PRODUCT CHANGE NOTIFICATION

#PCN-DCT-HDLS-11

Part#	Type Description
1689064	VS-08-BU-RJ45/BU

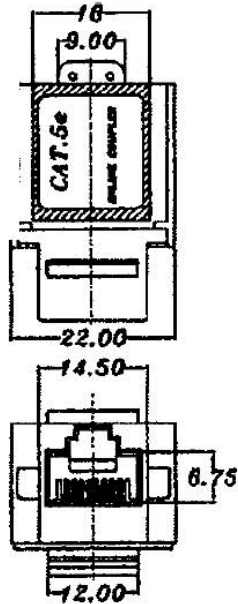
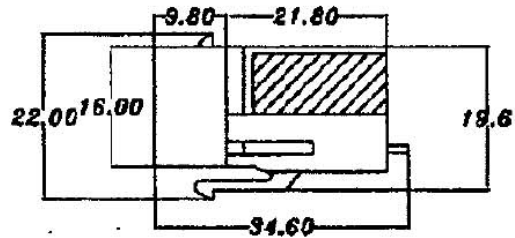
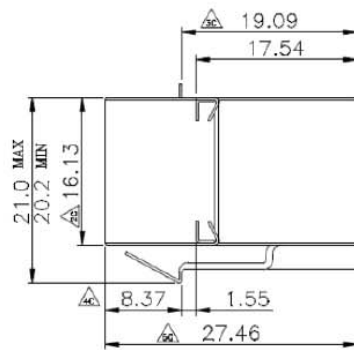
The female RJ45 connector has been optimized into a smaller version. All other technical data remains the same. The shield housing is also completely surrounding.
